TECHNICAL MEMORANDUM

Project: Tukwila Elementary Site Improvements

Subject: Traffic and Access Review

Figure 3 - Proposed Improvements

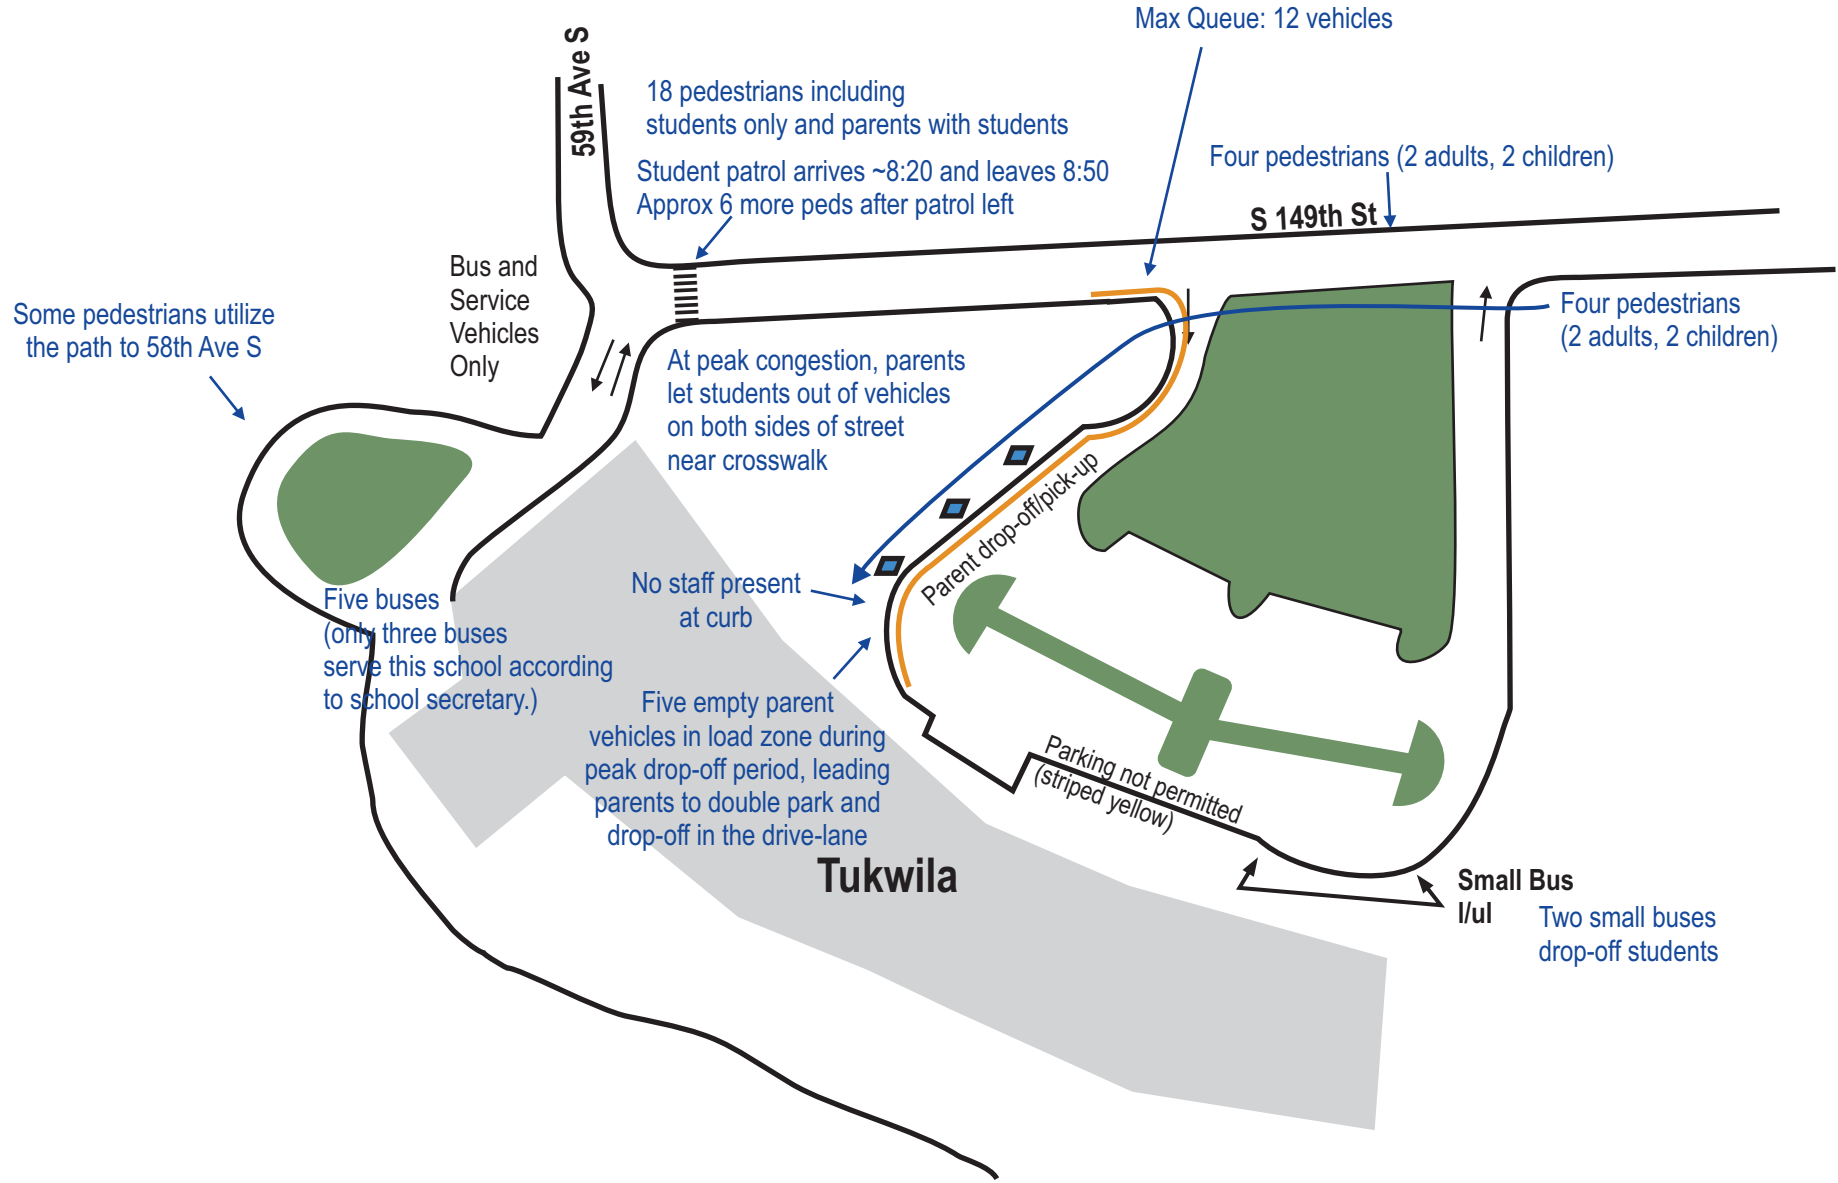
The following review comments refer to the plan set provided by Rolluda Architects titled *TUK DD 20181107* (see Figure 3). The proposal would add a new northern bay of parking with a new drive aisle. It would also enlarge the school-bus loop to the west and considers adding staff parking to the bus loop that would be loaded from the north.

Parking and Load/Unload: The existing lot is small and was approximately 80% utilized outside of the peak arrival and dismissal periods. The additional parking could provide more on-site space for drivers to use for student drop-off/pick-up and reduce use of the on-street spaces. With the additional northern segment of parking, drivers could more easily circulate within the site while waiting for their child(ren).

The option to add parking within the school-bus loop could provide additional parking spaces in the main lot to accommodate load/unload activities. However, this would only be useful if staff were relocated to the new stalls. Since overall operations were generally good, the benefit of the additional parking stalls may be marginal unless there is staff demand to park on that side of the building.

Pedestrians: The proposed changes are not expected to negatively impact pedestrian operations. Added parking in the main lot with a drive aisle would better accommodate on-site vehicular circulation and could reduce vehicle trips in and out of the access driveways, in turn reducing the number of vehicle trips crossing pedestrian paths at the driveways.
